FOUNDATION REPORT

US 50, Silva Valley Parkway Overcrossing

Bridge No. 25-0127

Subject: **FOUNDATION REPORT**
US 50, Silva Valley Parkway Overcrossing
Bridge No. 25-0127
03-ED-50; PM R1.8; EA 03-1E2901

FOUNDATION PLAN SHEET (ENGLISH) (REV.7/16/10) ORIGINAL SCALE IN INCHES FOR REDUCED PLANS 0 1 2 3 UNIT: 03-1E2901 PROJECT NUMBER & PHASE: 0300000258 DISREGARD PRINTS BEARING EARLIER REVISION DATES 07/28/10 11/08/10 03/23/12 SHEET 3 OF 24

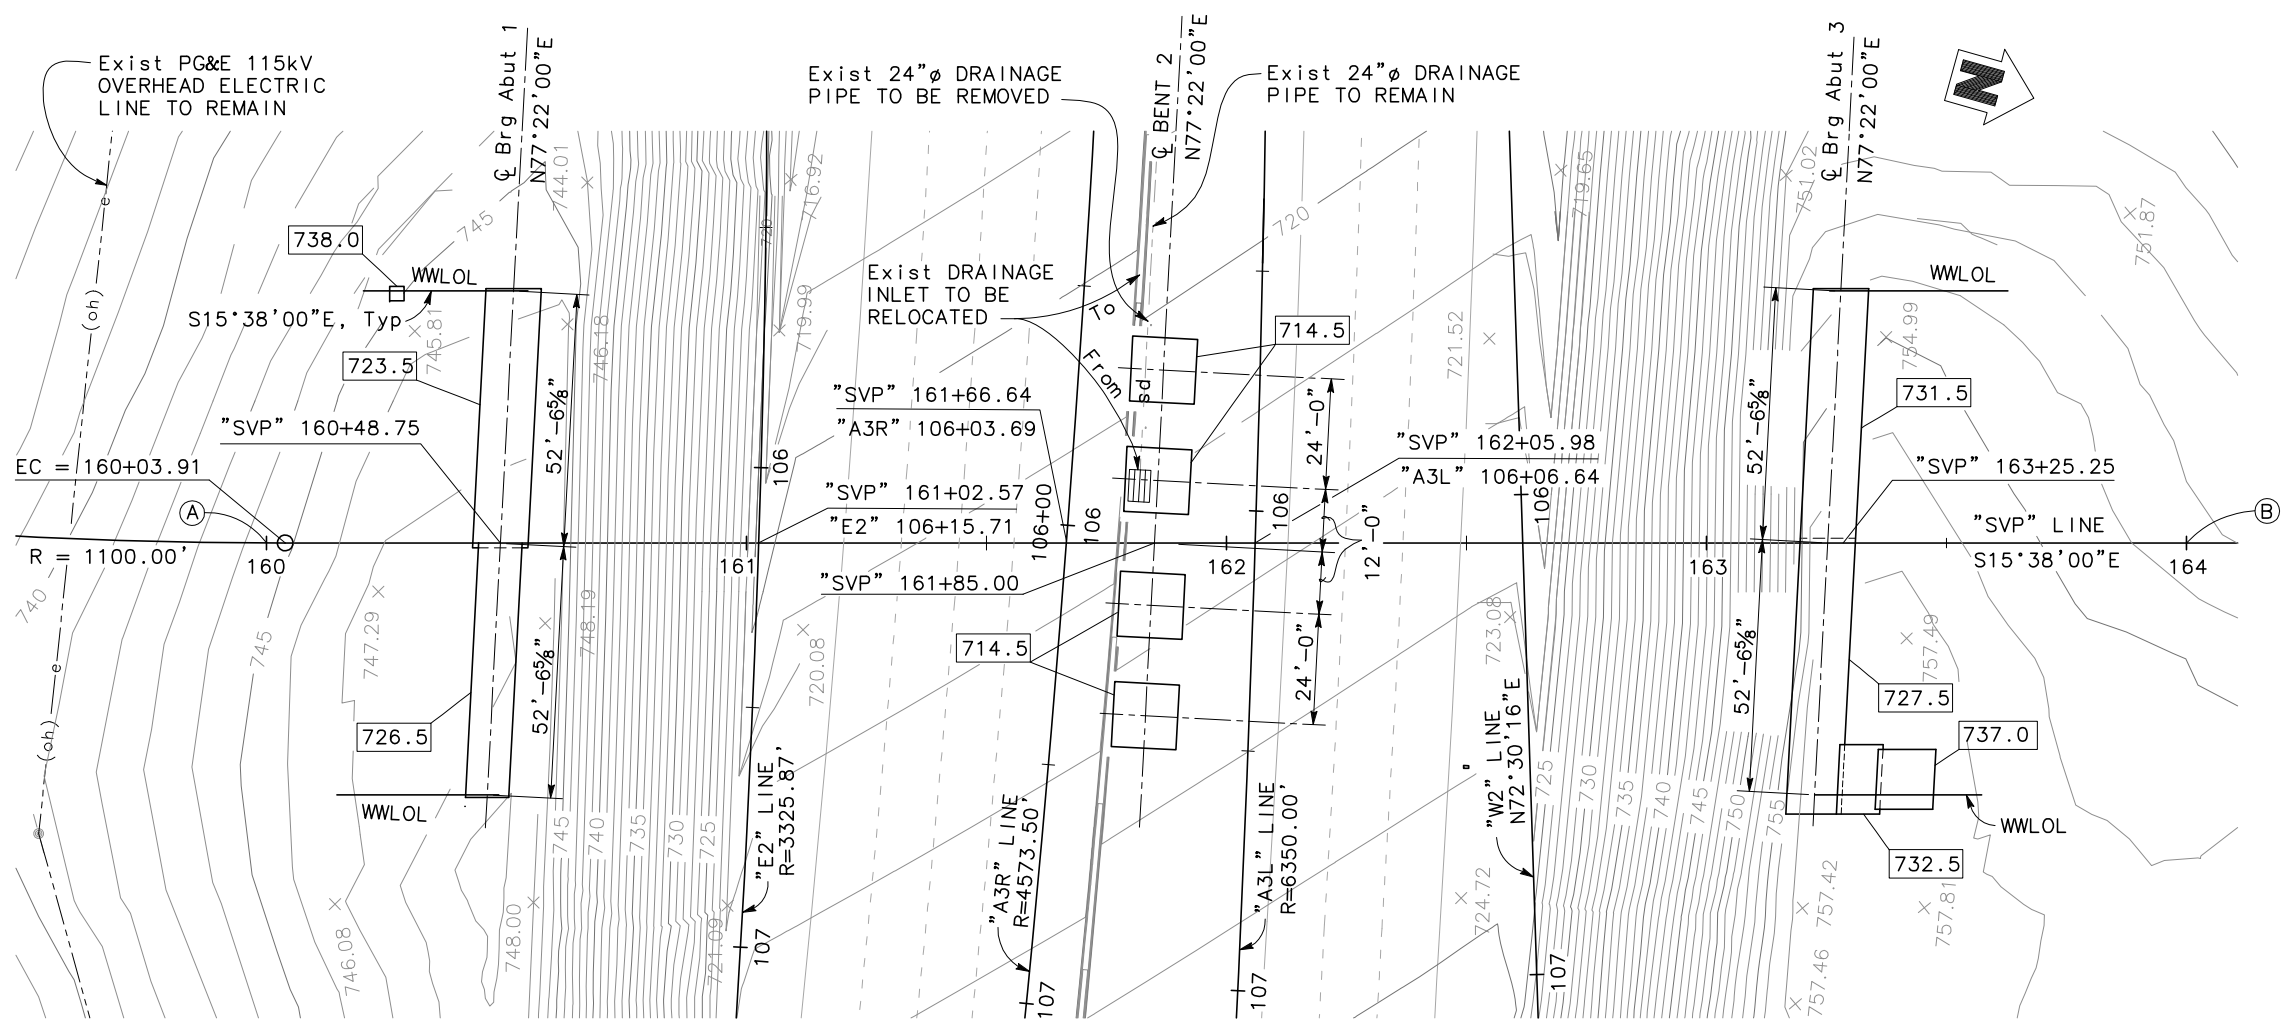
2	Silva Valley Pkwy OC, Br. No. 25-0127 Foundation Plan, Sheet 3 of 26 and Log of Test Borings 1 of 4, Sheet 23 of 26	The plans indicate that the proposed construction will require approximately 20' or more of excavations in rock for abutments 1 and 3. Depending on the actual rock conditions, difficult excavation maybe encountered. Use of air tools or blasting may be required. This comment has been provided during Type Selection. If blasting is used, attention should be given to specifications that loose materials (blocks, etc) should be cleaned and cavities should be backfilled with structure concrete in footing excavations. This comment applies to some other structures too.	Rock excavation is addressed in the Geotechnical Design Report and additional commentary is added to the Foundation Report. Removal loose material and backfill of cavities is addressed in Section 11.1.	
3	Silva Valley Pkwy OC, Br. No. 25-0127, Draft Foundation Report, Appendix D, Calculations and Analyses, Bearing Capacity on Rock	Two values for Coefficient of Nms are shown. One value is identified as 0.024. Another value 0.05 is actually used in calculation.	Nms value of 0.05 is applicable and the calculation is corrected to be consistent.
